From: Griffin, Tim (Contractor)
Sent: 09 April 2026 13:21
To: Harrison, Liz
Cc: Oliveira, Marta (Contractor); Dyer, Tim; Ellison, Mark
Subject: Re: F/26/101013 Oak Cottage, Botley - landscape comments

I have read through the DAS, and my comments that follow below focus on the Landscape General Arrangement plan:

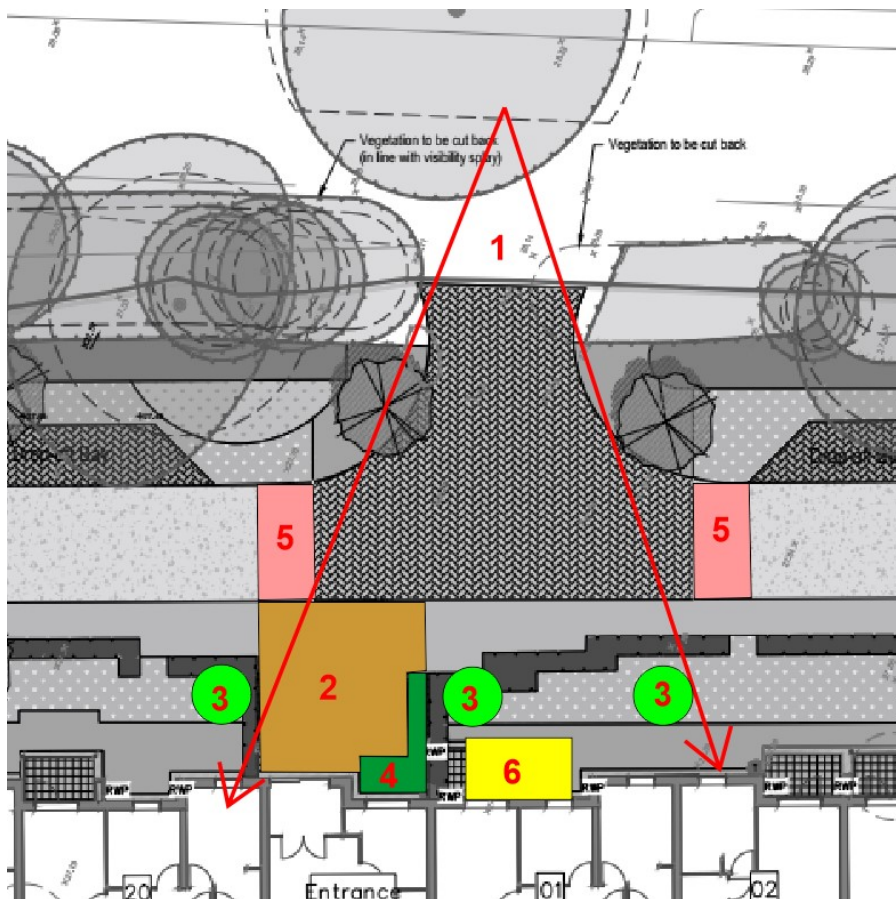
a/ The plan notes that vegetation will be cut back in line with the visibility splays either side of the entrance. In order to assess the depth of any cut required, and to ensure wholesale vegetation removal is not necessary, please add the required visibility splays on plan. This boundary vegetation provides important screening and contributes to softening the streetscene along Winchester Road.

Should there be any locations where retention of vegetation is unrealistic, this will need to be replaced with native mix planting supplied at 1.5m+ high for decent immediate effect.

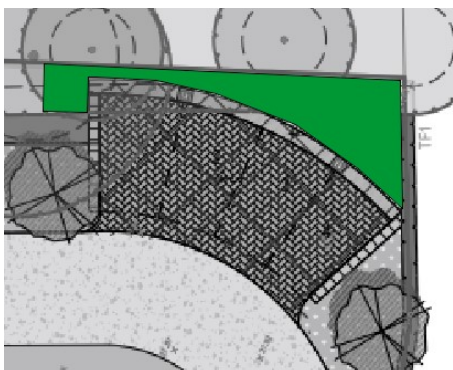
b/ The design of the entrance area is important as it will be seen in views from Winchester Road and marks the arrivals into the building. I suggest that Terra Firma refine the design to give the area an uplift.

My rough mark up below may help:

1 - Important vista from Winchester Road

2 - Introduce high quality block paving to provide entrance with distinctive 'feel'. Paving stretches across tarmac path to road edge

3 - Small flowering trees or large specimen/shaped specimens to frame entrance and soften elevations (sufficient size to have impact/softening effect)

4 - Relocate bike hoops elsewhere on site and move seat forward to create space for shrub planting to provide added interest in this key area

5 - Extend block paving on road to tie in with edge of note 2 surfacing & match on other side of hammerhead as indicated for balanced effect

6 - Shift patio slightly away from entrance area and plant narrow strip between patio & hedge with shrubs

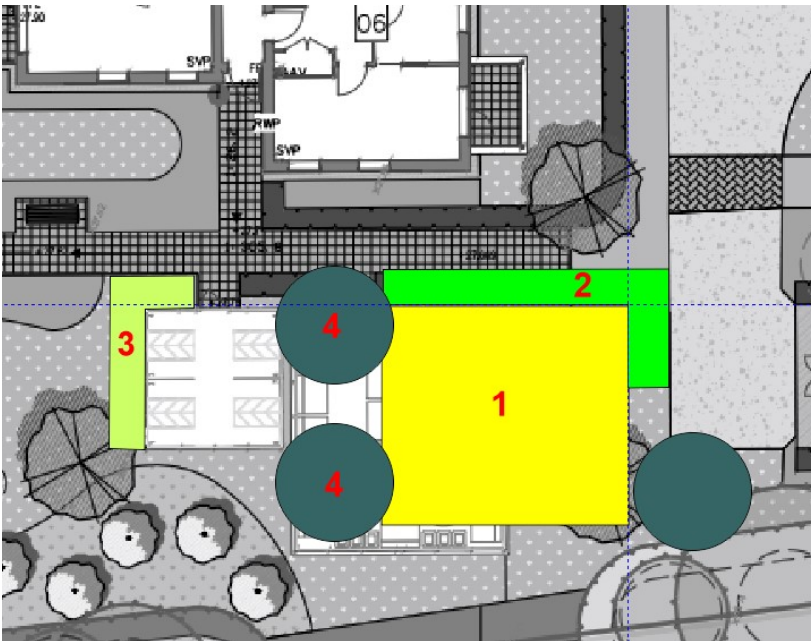
c/ The location of these parking bays continues to concern me as they may well result in gaps opening in the boundary screen resulting in open views from Winchester Road.

Please add a sweeping section of new native planting as per the area in green above.

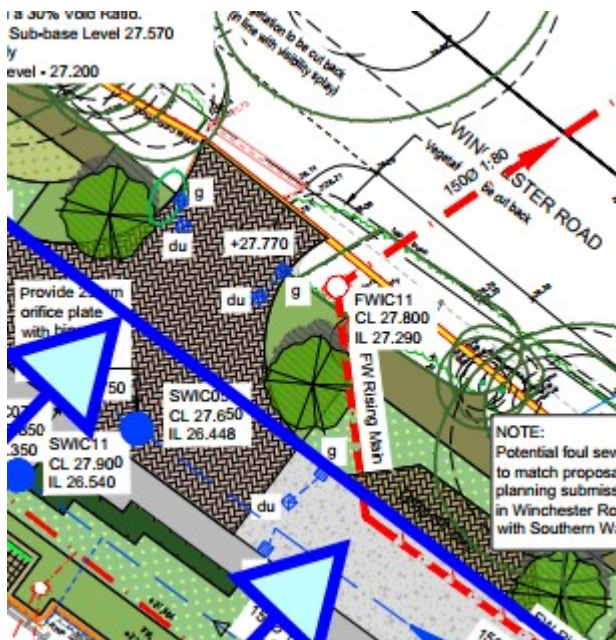
e/ I suggest the location of the bin store and scooter store be re-considered as the bin store may attract various pests/emit bad odours.

- 1 - bin store relocated
- 2 - robust planting to soften bin store in views
- 3 - Planting to soften scooter store
- 4 - Space for tree planting (and fragrant shrubs?)

Please consider a green roof for the scooter store for added habitat value.

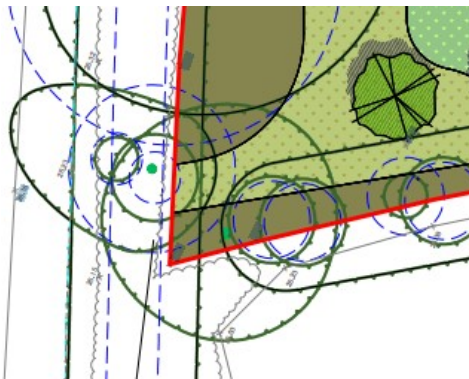
f/ The FW connection shown on the drainage strategy plan passes close to a new tree location and will result in the loss of some existing vegetation:

This should be re-routed under the new access drive to avoid adverse impact on the planting.

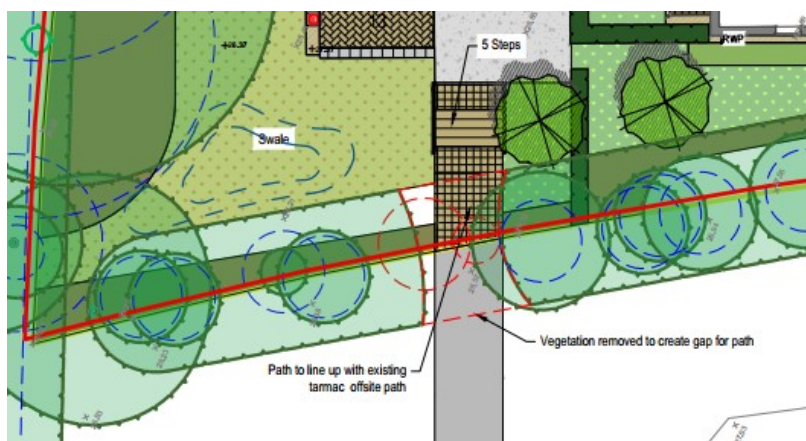
g/ The native shrub planting indicated along many boundaries is welcomed since maintaining and bolstering lower-level boundary screening is crucial to soften the impact of this development. However, there is an odd gap in the continuity of this planting which should be closed (unless there is good reason for the gap!):

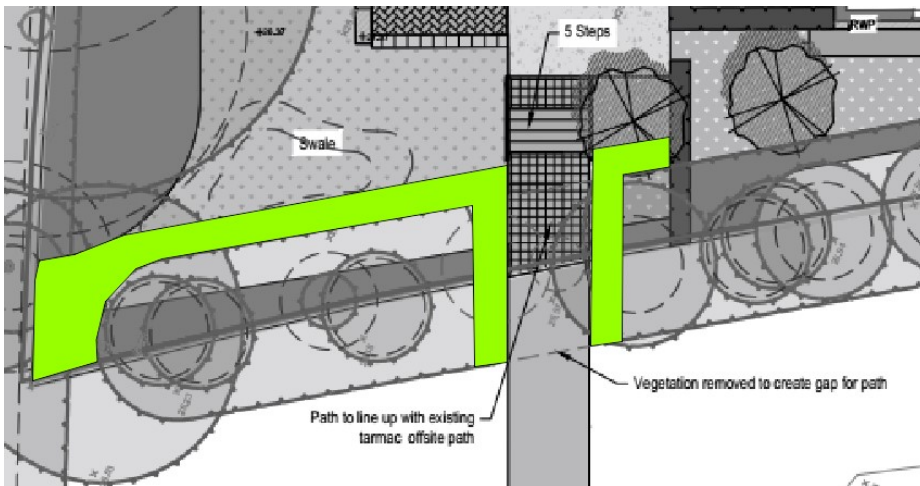
h/ I am not clear on the arrangement of planting here as it seems that there is new planting within existing vegetation?

Perhaps the arrangement below is more realistic with planting pulled out to the edges of existing vegetation. It also fills the gap identified above and runs down both sides of the new path (where inevitably there will need to be restorative planting after the path installed).

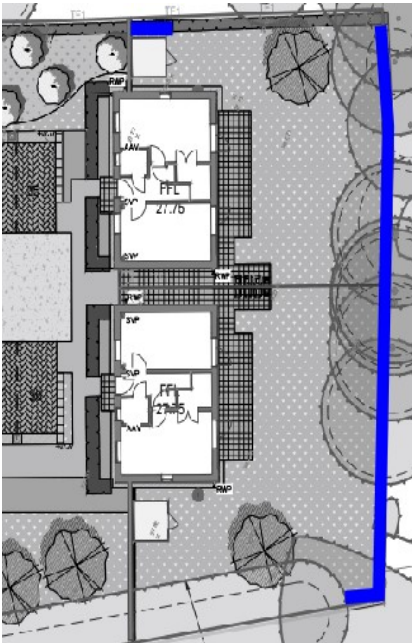
j/ The submitted plans and perspective views show limited higher level planting to soften the building elevations:

Further higher level planting is required along 3 sides to filter views and improve the setting of the development.

Small trees such as Amelanchier 'Robin Hill' or Prunus shimidsu 'Sakura' are possible options or if preferred more architectural 'umbrella' shaped trees that can be kept clipped to shape:

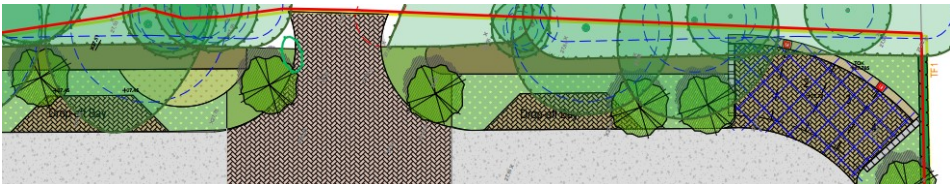
k/ The native mix hedge planting to be extended as below (blue lines) to create a connected wildlife corridor:

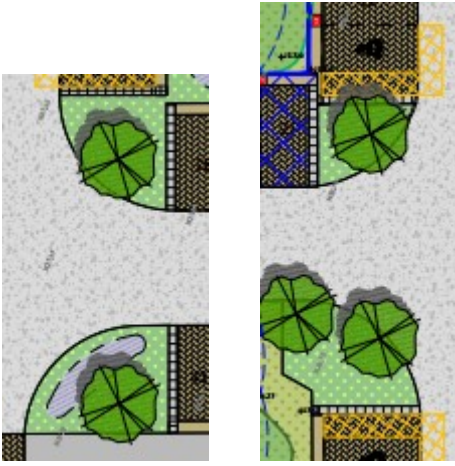
l/ These parking/drop off bays should be reinforced gravel to reduce impact on the retained trees:
